ADDENDUM NO. 3

Client: City of Elwood
Municipal Building Renovation

Issue Date: November 2, 2026

SHEET NUMBER:
A001

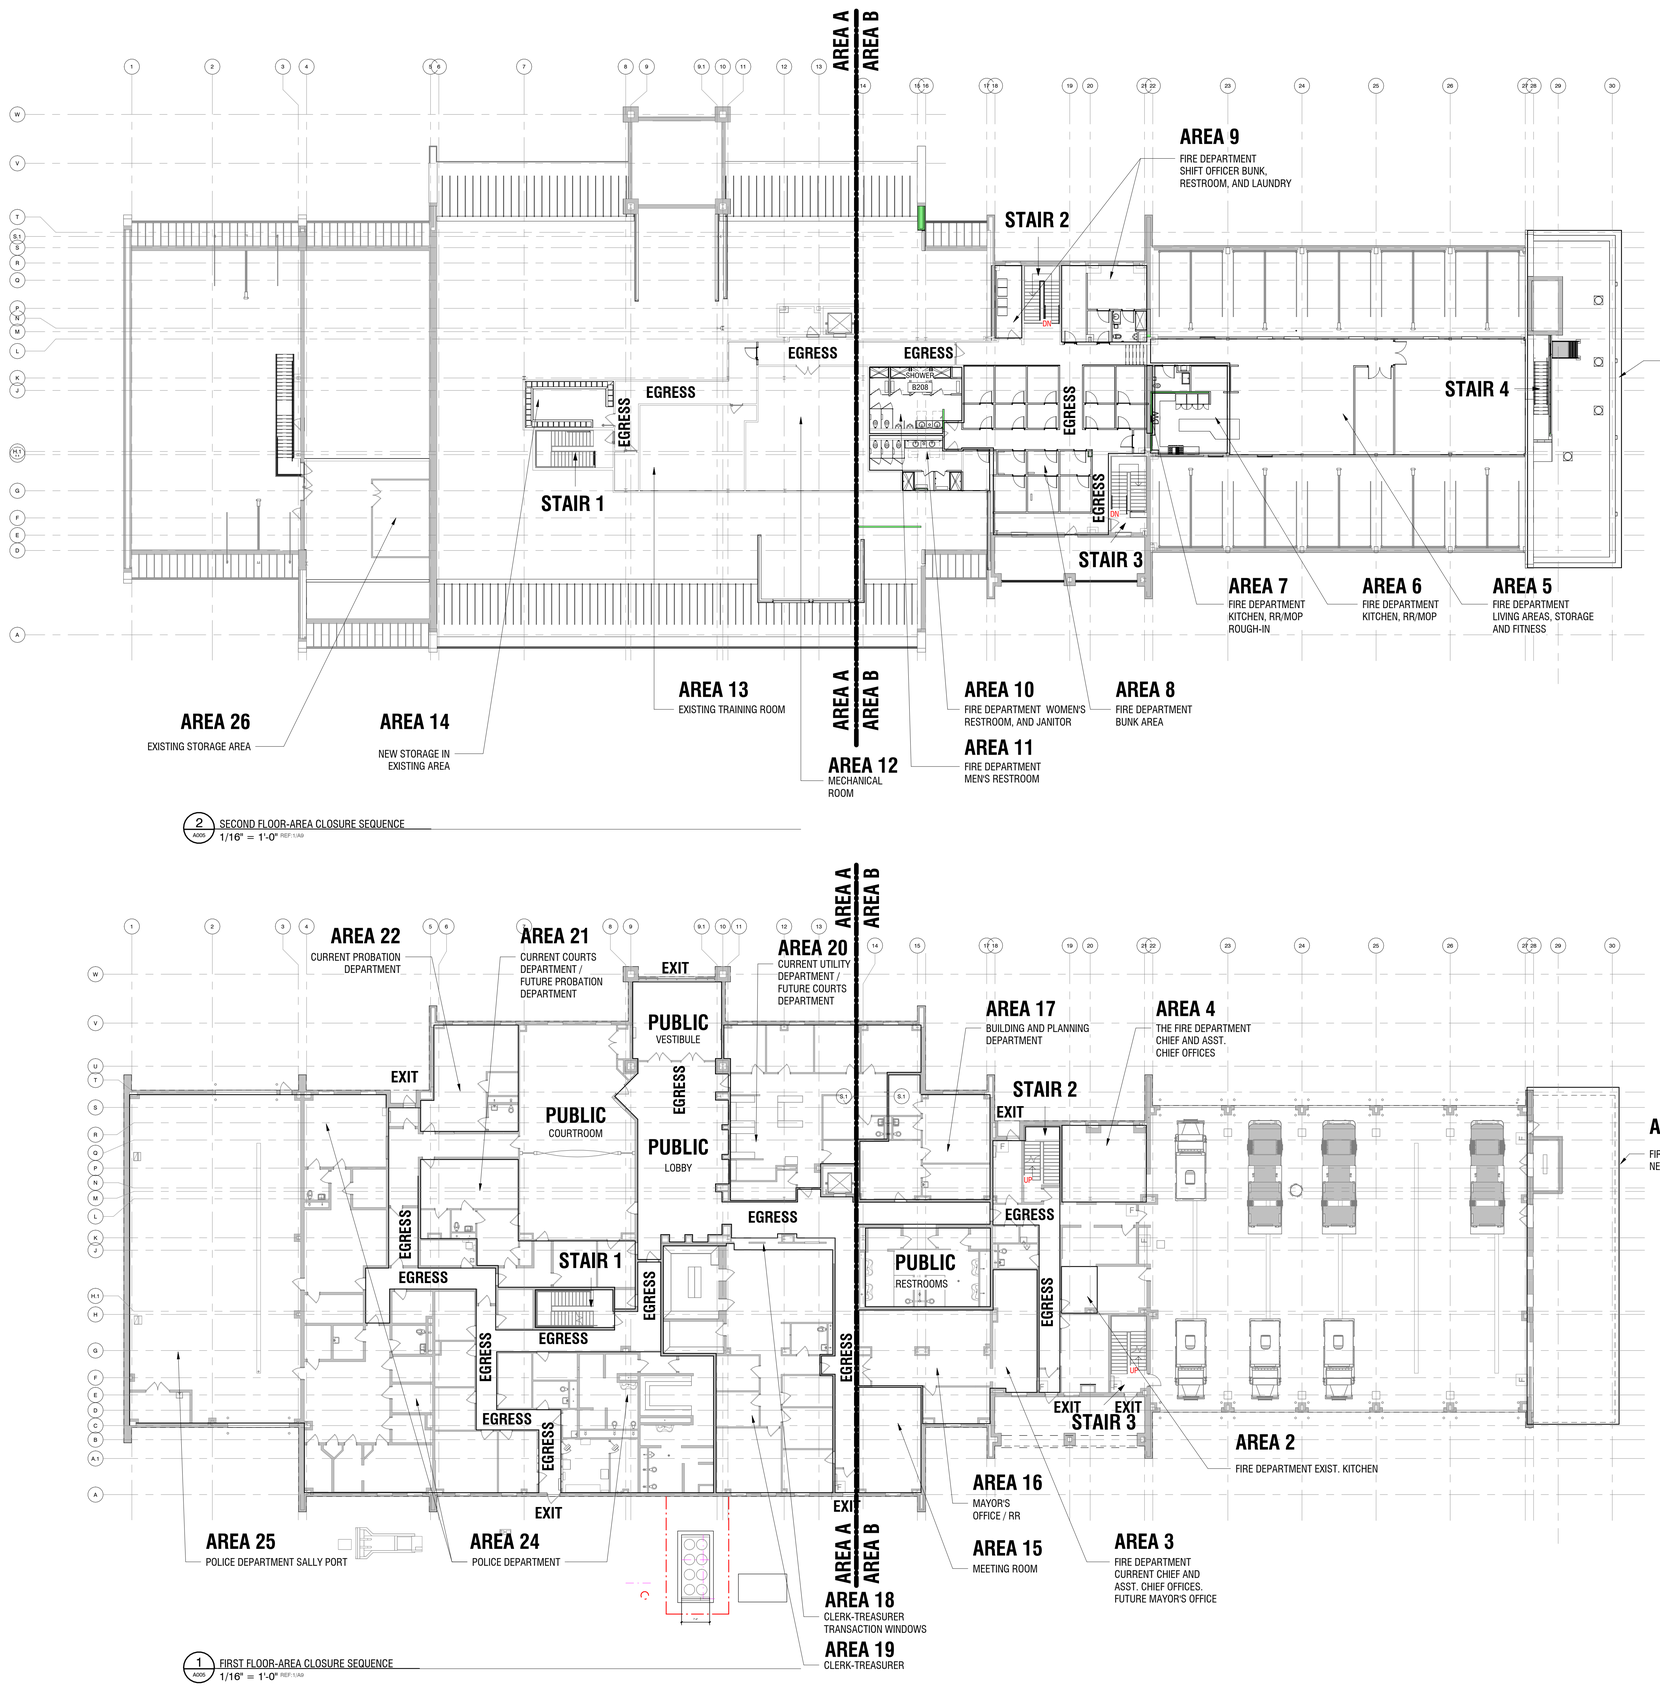
1. **Sheet No. A001 – GENERAL INFORMATION**

a. Revised general notes
    b. Revised Partition types schedule
    c. Added wall type S4D

SHEET NUMBER:
A005

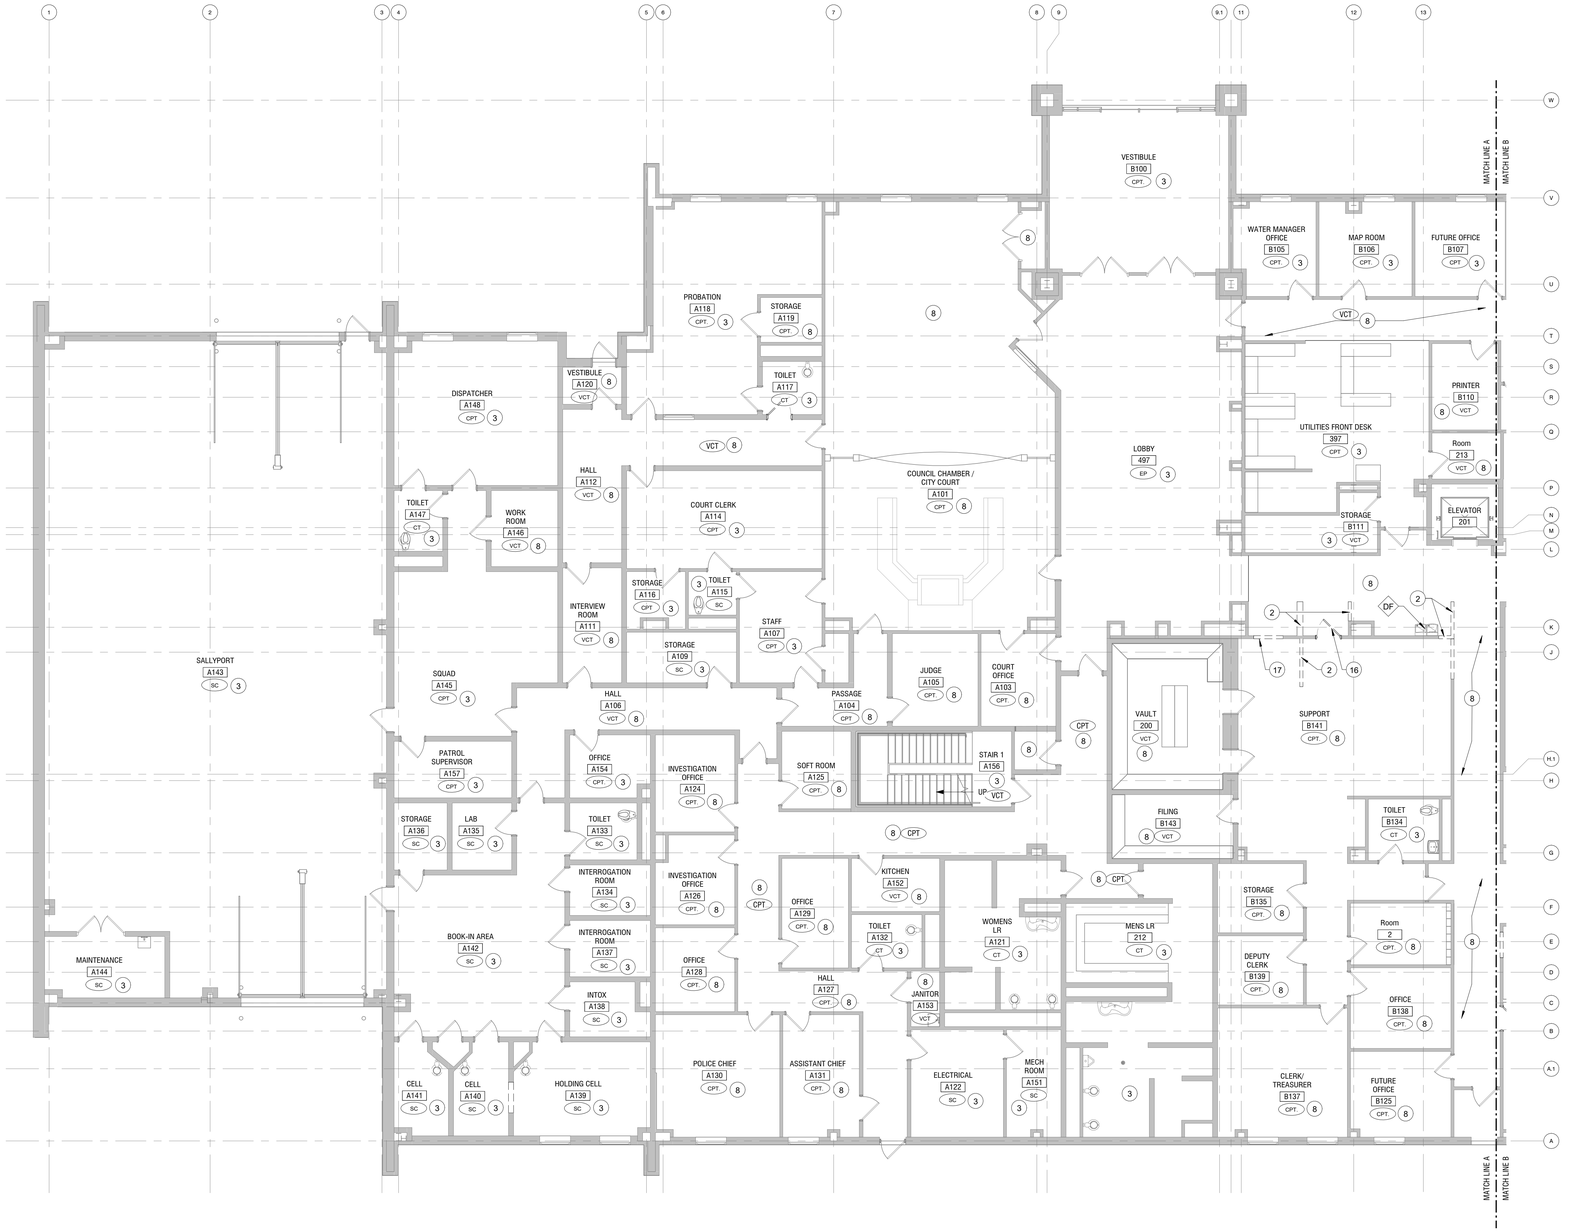
2. **Sheet No. A005 – Area Closure Sequencing Notes**

a. Updated the area closure sequence notes.

SHEET NUMBER: AD101

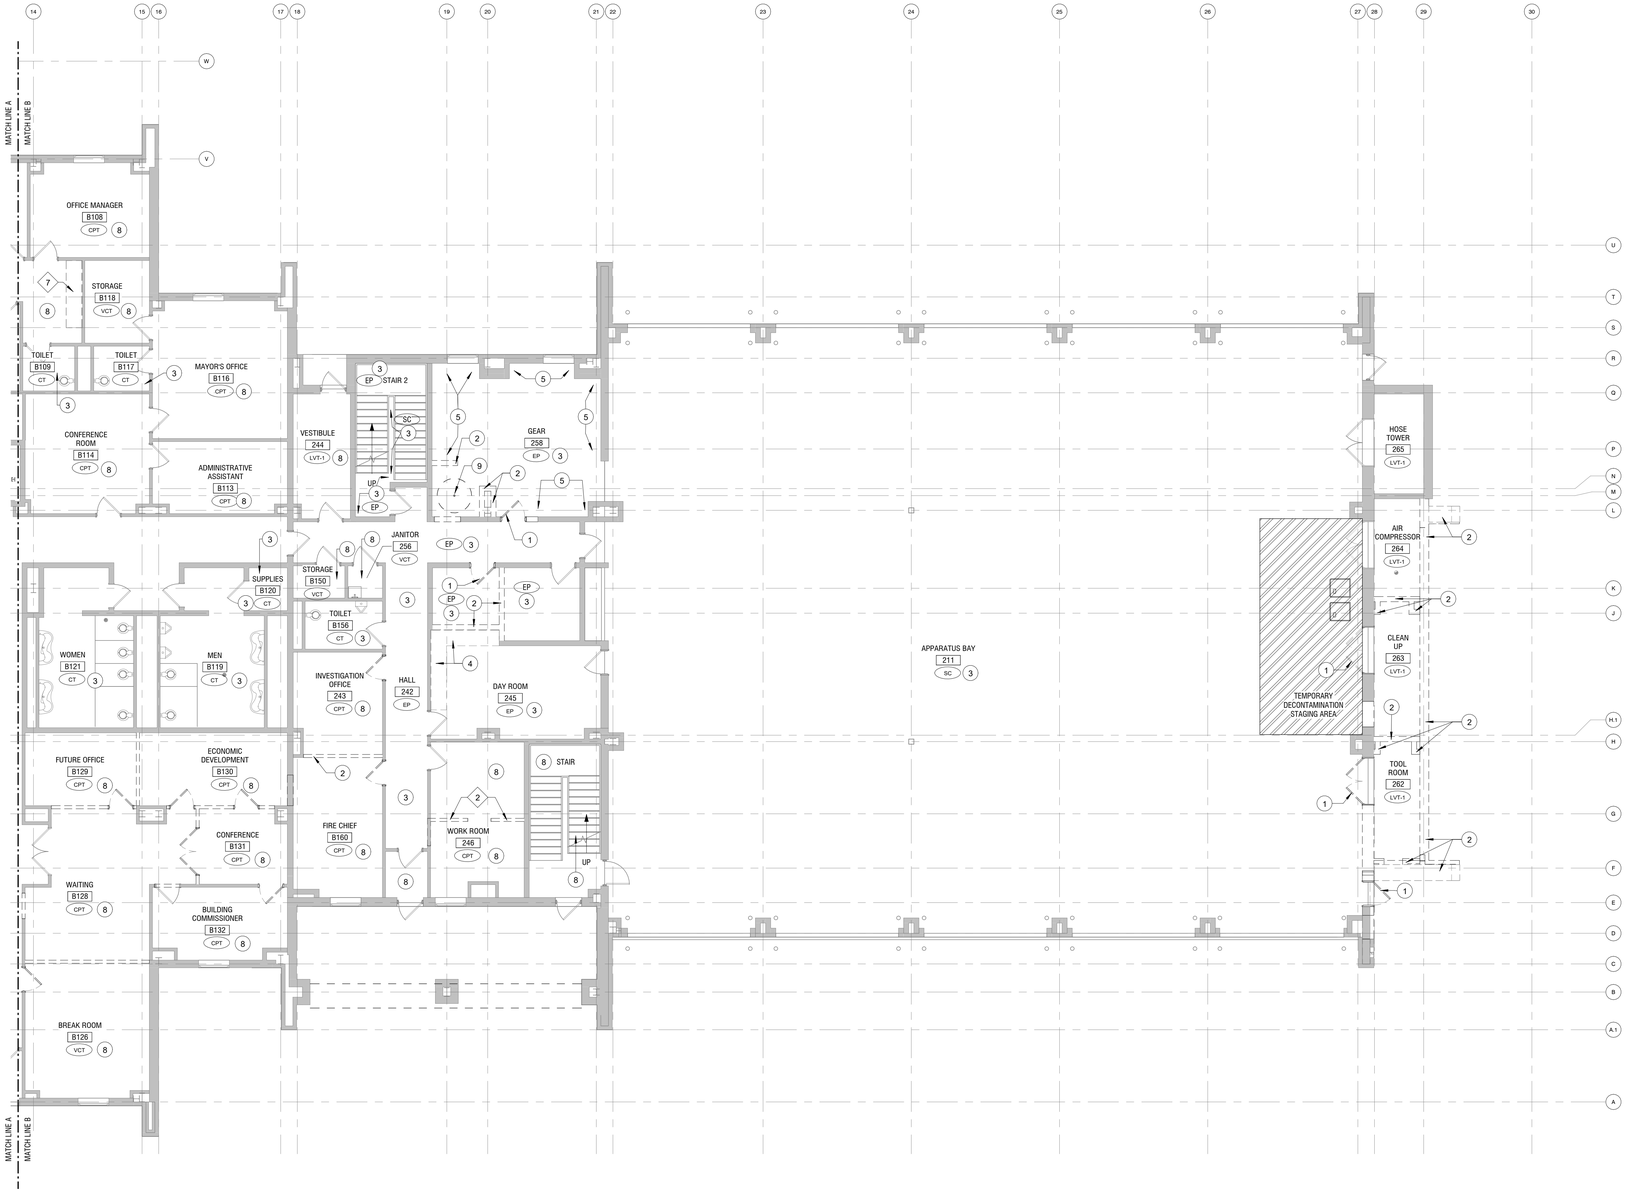
3. **Sheet No. AD101 – AD104 - Demolition Plans**

a. Updated plans to reflect the existing flooring accurately and the scope of work for future flooring finishes.
    b. Revised Demolition Legend

SHEET NUMBER:
AD134

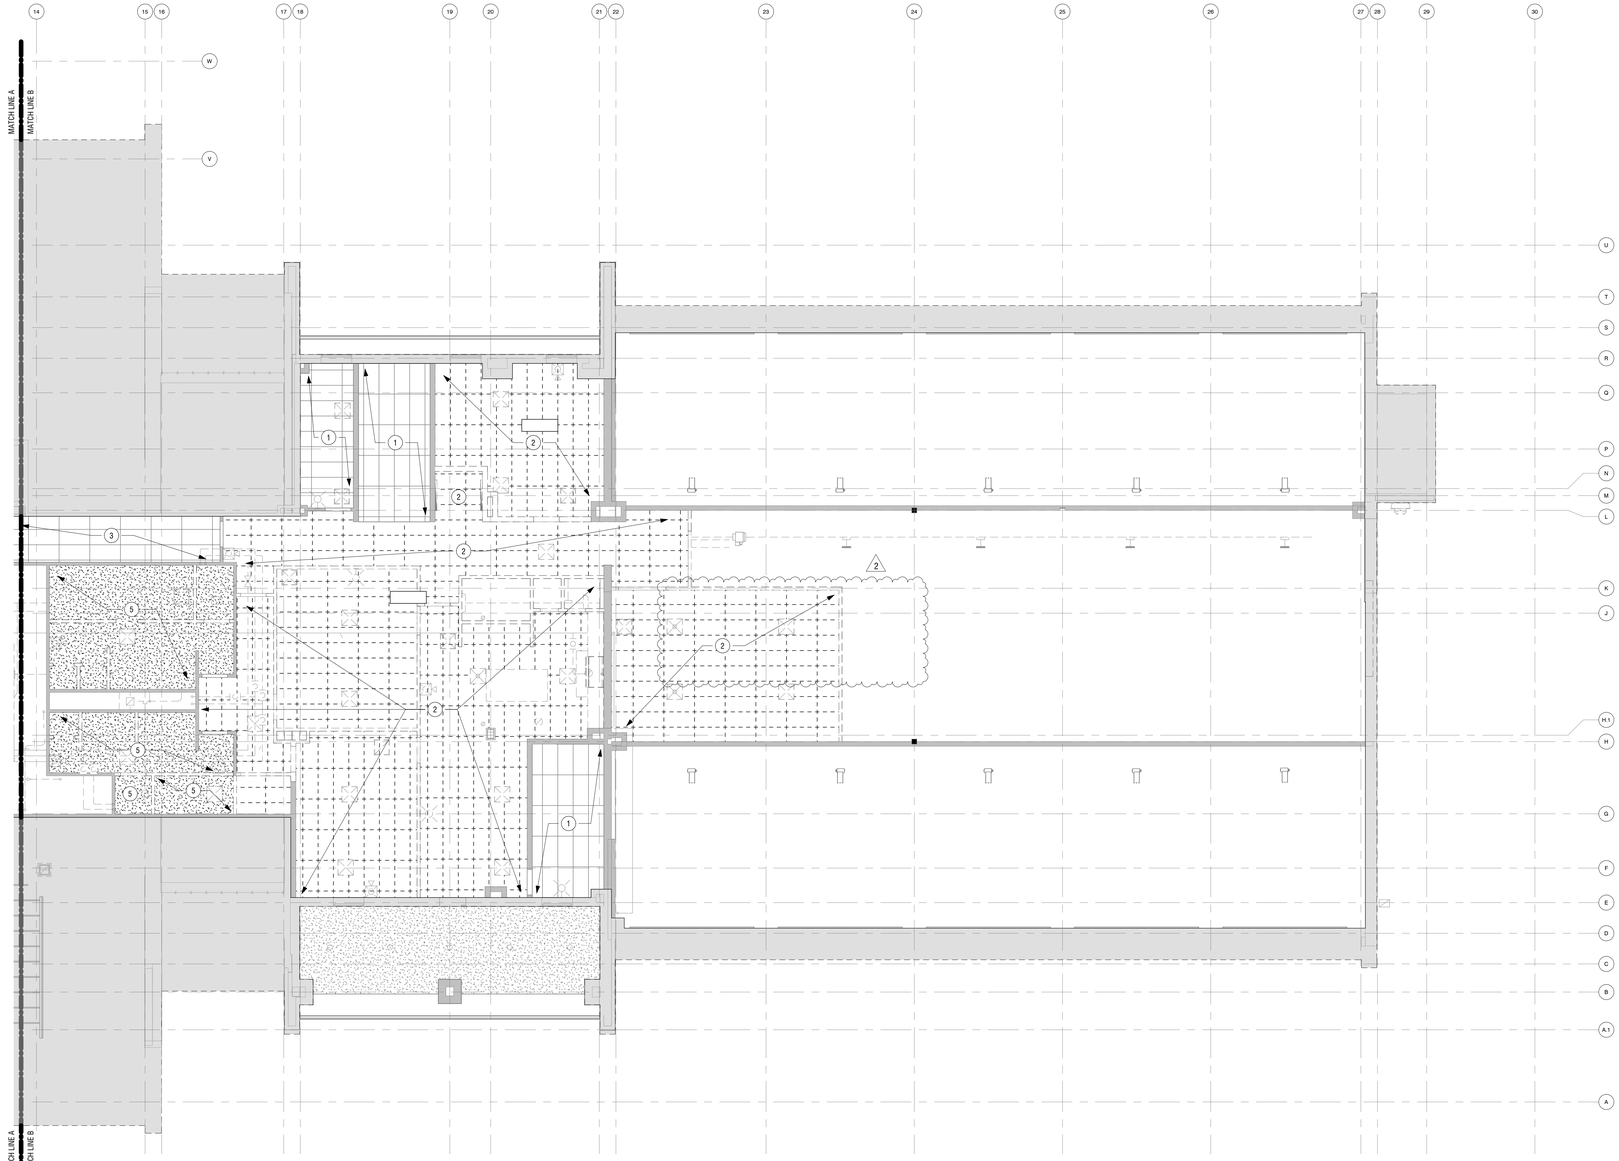
4. **Sheet No. AD134 – Area "B" – Second Floor RCP Demolition Plan**

a. Revised Key Notes
    b. Deleted keynote "18"

SHEET NUMBER: A102

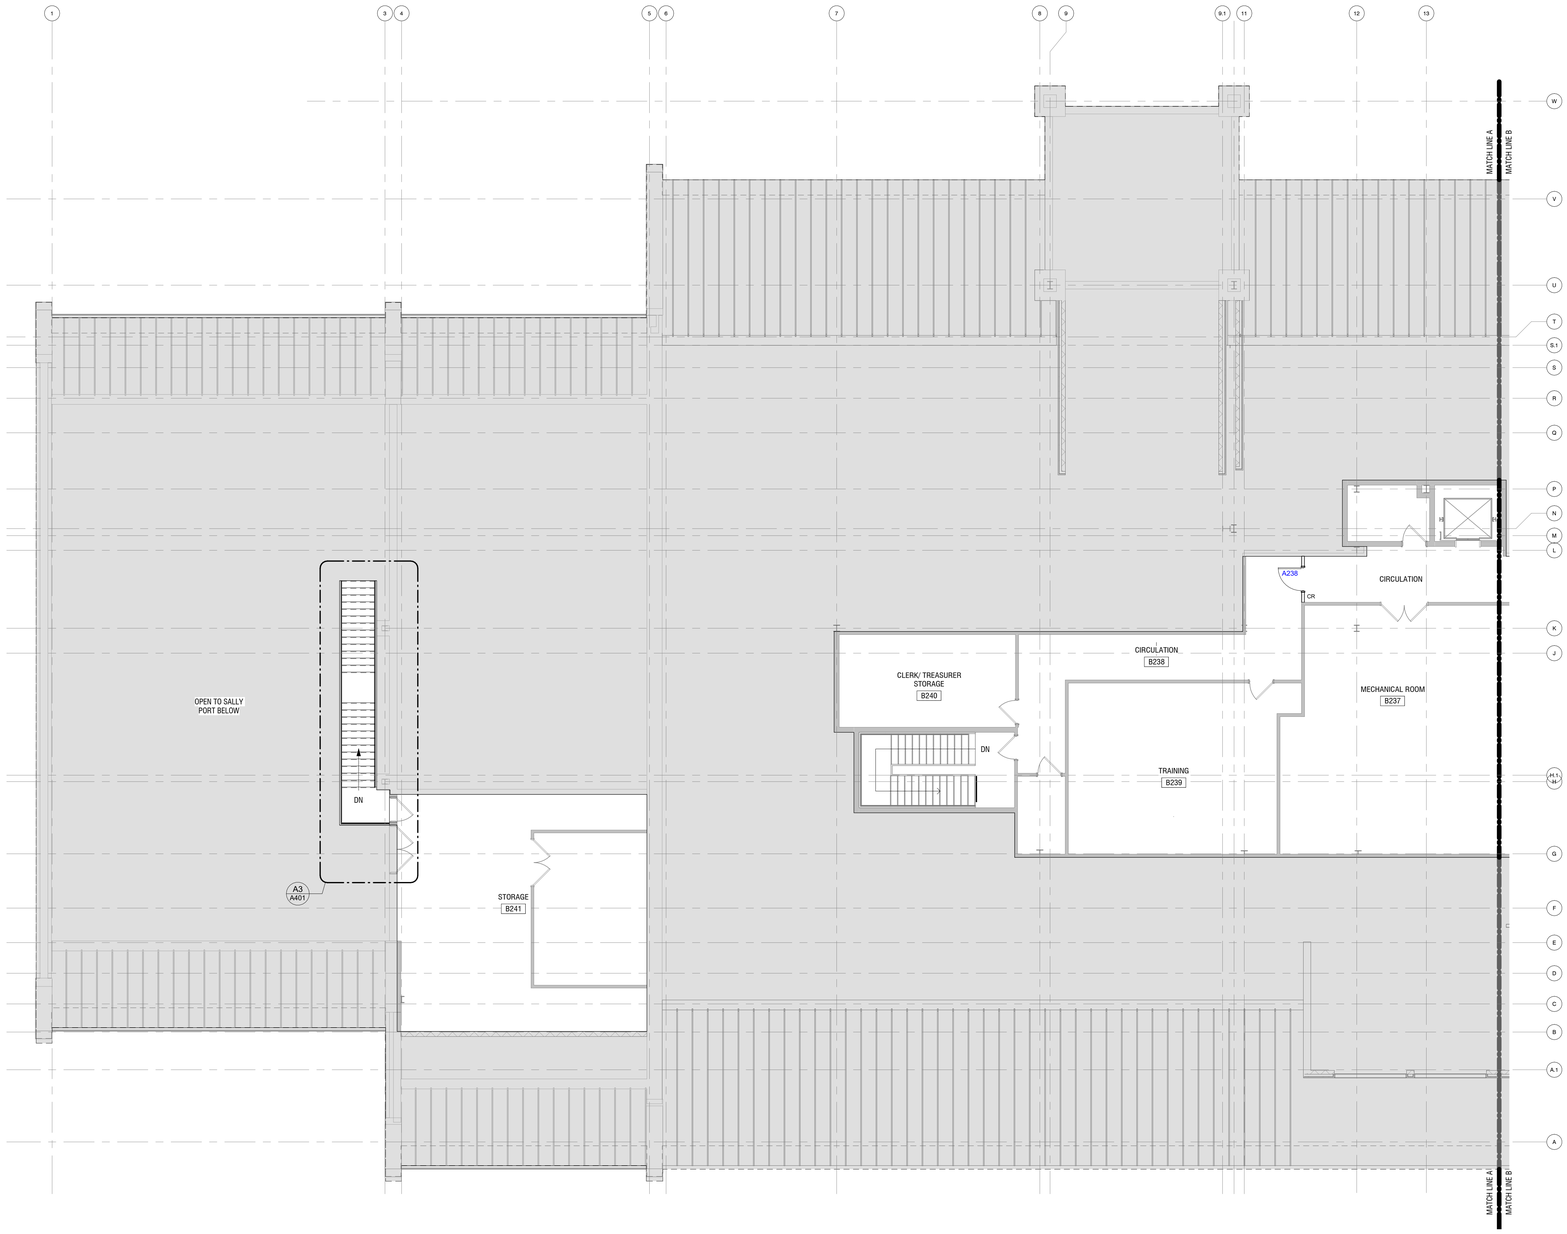
6. **Sheet No. A102 – Area "B" – First Floor Plan**

a. Add Floor Plan Legend
    b. Revised View Names
    c. Revised Wall Tags
